# REPAIR OF THE INVERTED GEAR RACK IN-WALL (SCHWINTEK) SLIDE-OUT SYSTEM

TSB Number:	146-001-2022		
Product:	Inverted Gear Rack In-Wall Slide-Out System manufactured between October 2021 and January 2022		
Date:	June 24, 2022	Labor Rate:	5.0 Hours Allowed (2.5 hours per side)

**NOTE:** This bulletin supersedes service bulletin 146-001-2022 dated June 22, 2022, which should be removed from your files. This revision provides clarification around the repair kits and corrects an error in kit "C" in the parts tables.

## Identifying the Inverted Gear Rack In-Wall Slide-Out System

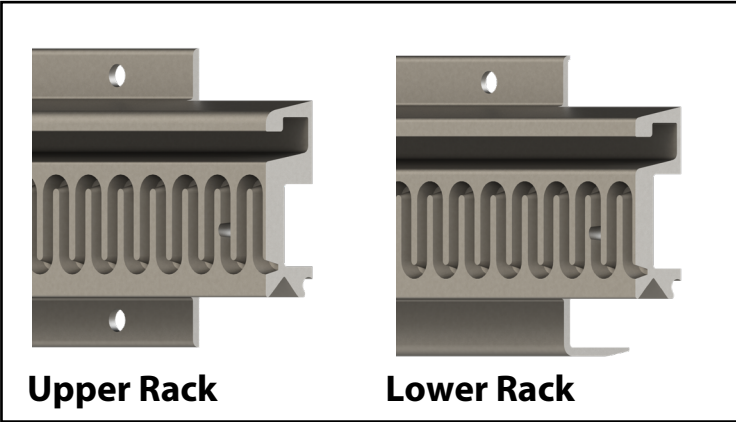
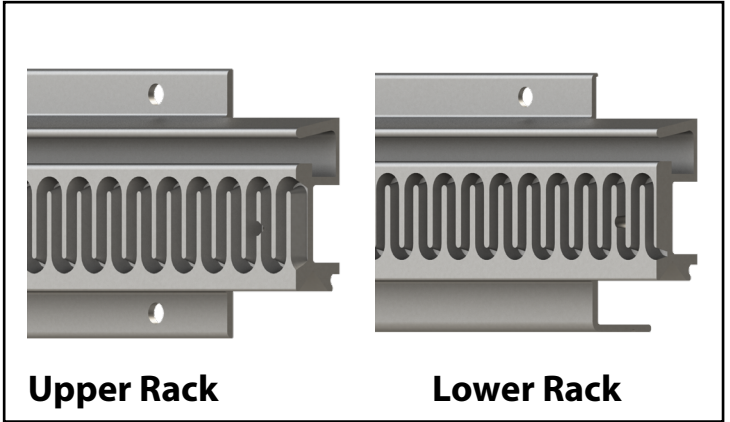
The inspection will be to validate the system as being part of the Inverted Gear Rack In-Wall Slide-Out system. The profile of the gear rack will be as shown below under the subsection "Identifying The Inverted Gear Rack In-Wall Slide-Out System."

### Gear Rack Notch Options

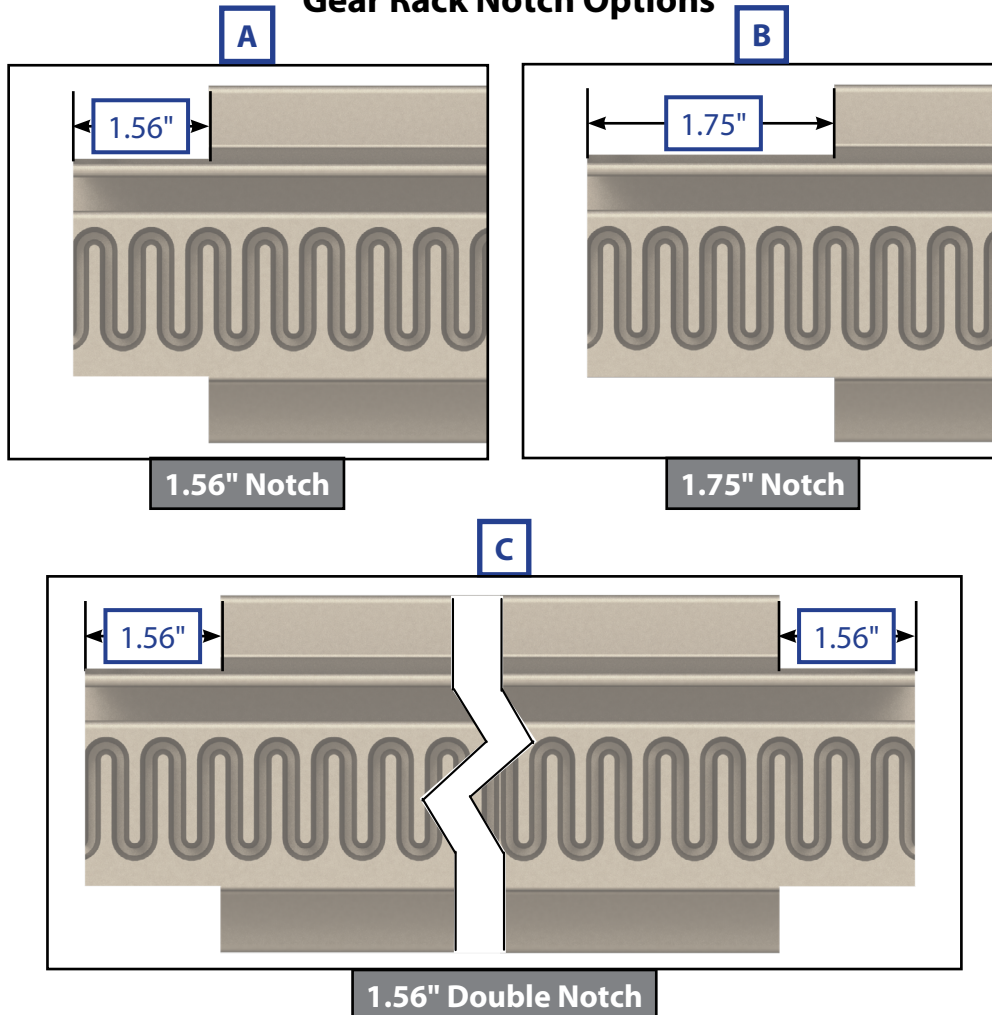
The most common gear rack notch option is 1.56" PN 2022108946. However, using the previous gear rack images to identify the notch, order the kit number listed below.

**NOTE:** Gear racks in (A) 2022108946 1.56" Notch and (B) 2022108947 1.75" Notch are 38" and can be cut to length. Gear racks in (C) 2022108948 1.56" Double Notch are 32" and can **NOT** be cut down. For the 1.56" Double Notch gear rack lengths other than 32", please contact Lippert Customer Care Center at (432) 547-7378.
